# APPLICATION FOR PERMIT

LOCATION **85-F-35 Spruce Ave. Peaks Isl.**  
1. Owner's name and address **William & Joan Murphy - 118 Kaylan So. Port** Fire District #1  #2  Telephone **799-1756**  
2. Lessee's name and address ..... Telephone .....  
3. Contractor's name and address **Mainline Renovations - Isl. Ave. Peaks Isl.** Telephone **766-2438**

To construct 6' x 8' 2nd story deck on rear of dwelling, also to install window in south side of dwelling, with 2nd story door, 2' addition to existing bathroom on 1st floor as per plans. 3 sheets of plans.

Re: 85-F-35 Spruce Avenue; Peaks Island.

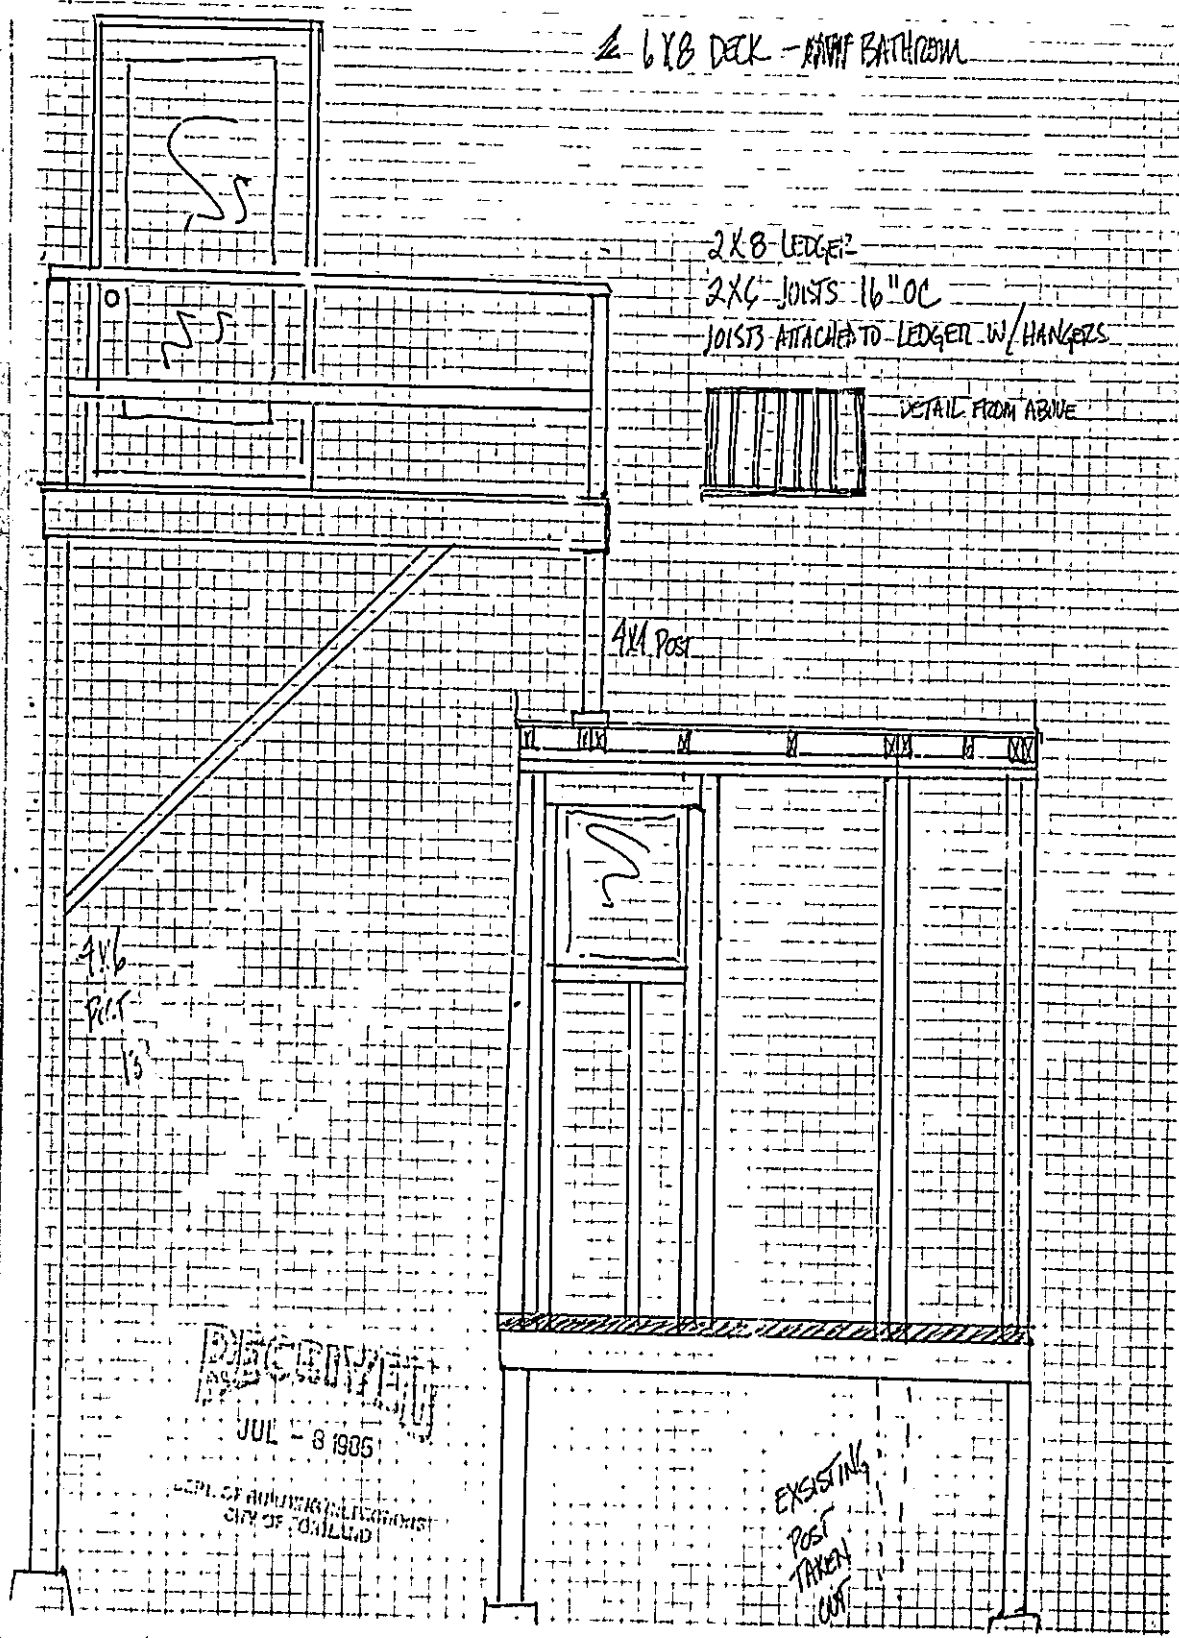
Guardrails: Porches, balconies, or raised floor surfaces located more than (30) thirty inches above the floor or grade below shall have guardrails not less than thirty-six (36) inches in height.

Required guardrails on open side of stairways, raised floor areas, balconies, and porches shall have intermediate rail or ornamental closures which will not allow passage of an object six (6) inches or more in diameter.
